RESPONSE TO REQUEST FOR FURTHER INFORMATION - 104-116 REGENT STREET, REDFERN

This letter has been prepared by Urbis on behalf of Wee Hur and relates to State Significant Development Application (**SSDA**) at 104-116 Regent Street, Redfern (**SSD-12618001**).

This letter responds to a Request for Information (**RFI**) issued by the Department of Planning and Environment (**DPE**) on 15 July 2022. DPE requested responses to additional submission by City of Sydney, Sydney Metro and one public submission following their review of the Response to Submissions (**RtS**) report submitted by Wee Hur on 15 June 2022.

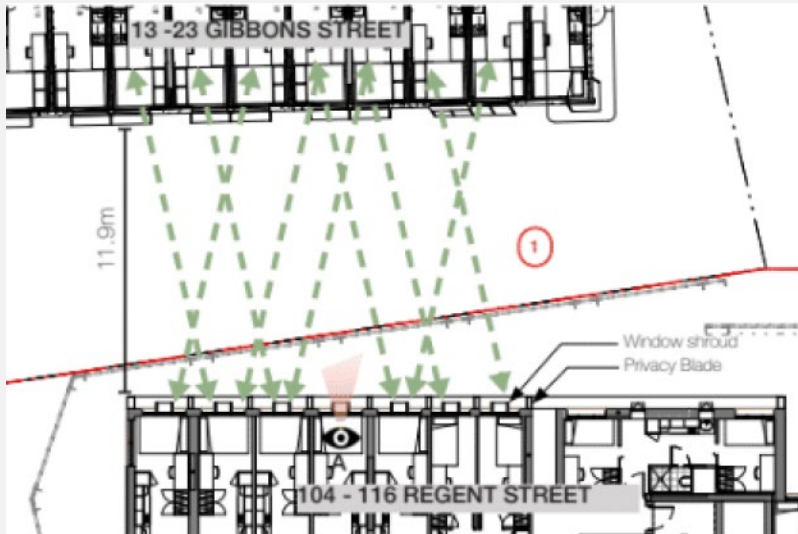
Address Council's issues regarding further activation of the ground floor and public artwork and their recommendations and conditions.	A detailed response to Council's issues regarding activation of the ground floor is provided at Item 1 in Table 2 below.
